TEN-T Priority Route Improvement Project, Donegal

Phase 2, Option Selection Report Volume C2-Section 2 Non-Environmental Appendices

Appendix C2.5 – Section 2 Road Safety Audit Stage F – Part 2

1.5 Stage F (Part 1) Road Safety Audit

Location: Eastern Tie-in at Pluck Roundabout

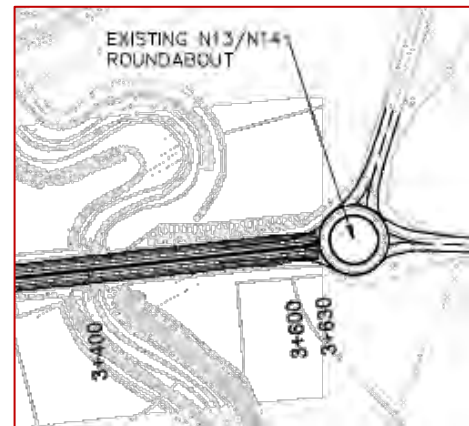
2.1 Problem

Recommendation

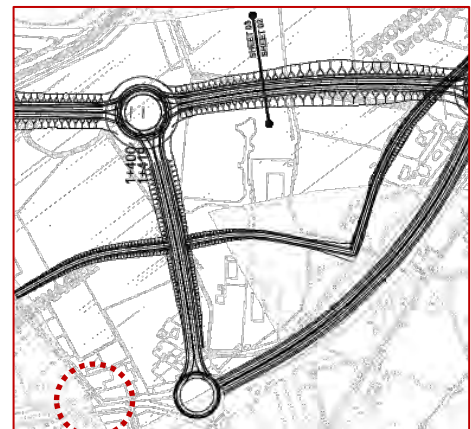
This section of road consists of a heavily trafficked four-lane single carriageway with numerous direct accesses onto it, and historically high numbers of collisions.

As part of this Scheme a new link road is proposed between two local roads in the lands north of the Dry Arch Roundabout and south of the River Swilly, passing under one arm of the new link road across the River Swilly, and the associated closure of the existing local road arm to the north-east of Dry Arch roundabout.

This may result in increased traffic through the existing at-grade junction on the N56 immediately north-west of the Dry Arch Roundabout. And changed traffic patterns. It is unclear if the existing junction can safely accommodate any additional traffic or increased right-turning volumes.

Summary: Absence of connectivity onto the existing N13, between the southern tie-in and the Dry Arch Roundabout, could lead to increased volumes of traffic on the local road network around the southern tie-in which cannot be safely accommodated.

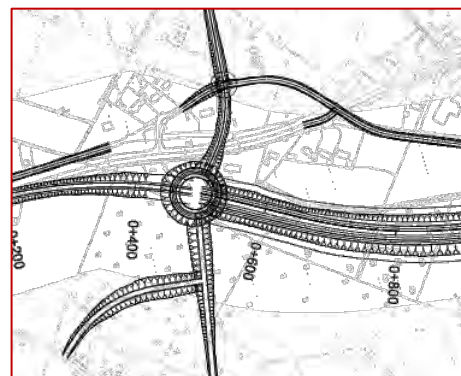
The proposed road layout at the southern tie-in does not include connectivity from the realigned N13 onto the existing N13 towards the Dry Arch Roundabout.

This could result in an increased volume of traffic on the adjacent local road network, which may not be able to cater for these increased traffic volumes safely.

Location: New Link Road under new Link Road across the River Swilly (north of the Dry Arch Roundabout and south of the River Swilly)

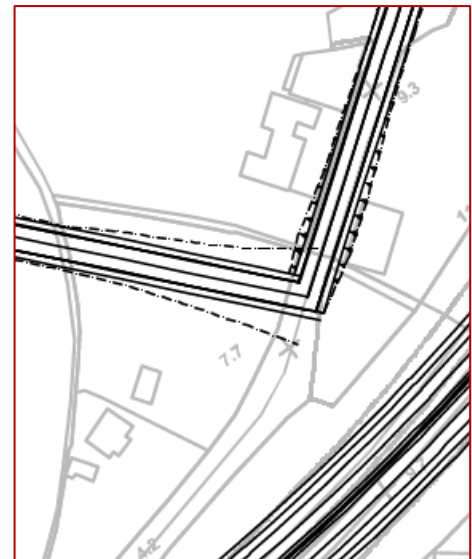
During the design development include measures to ensure drivers are adequately aware of the upcoming road layout.

Similarly, as drivers become familiar with the new road layout, and in particular the low likelihood of meeting traffic on one of the junction arms, they may be unprepared when a vehicle emerges from this arm which may have priority due to the junction layout.

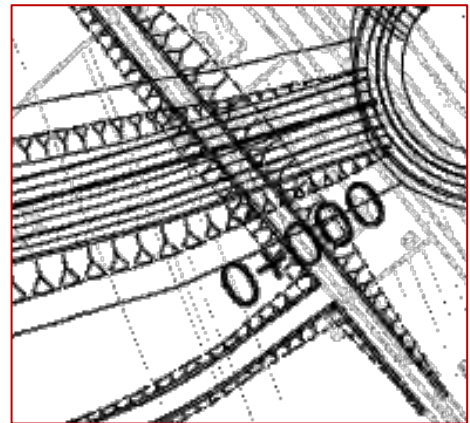
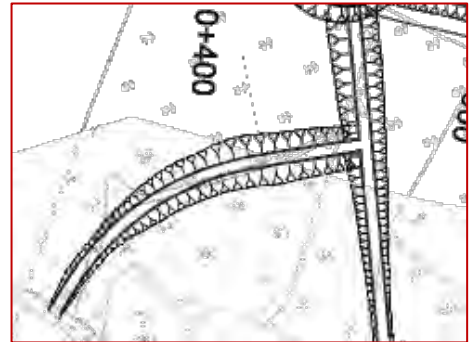
- 3.1 In a number of locations junctions/accesses on realigned side roads are indicated within cuttings or adjacent to proposed underbridges/overbridges.

During the design development ensure that the visibility splays for drivers exiting from the minor arm of these junctions is not obstructed by the earthworks or the nearby structures & associated parapets.
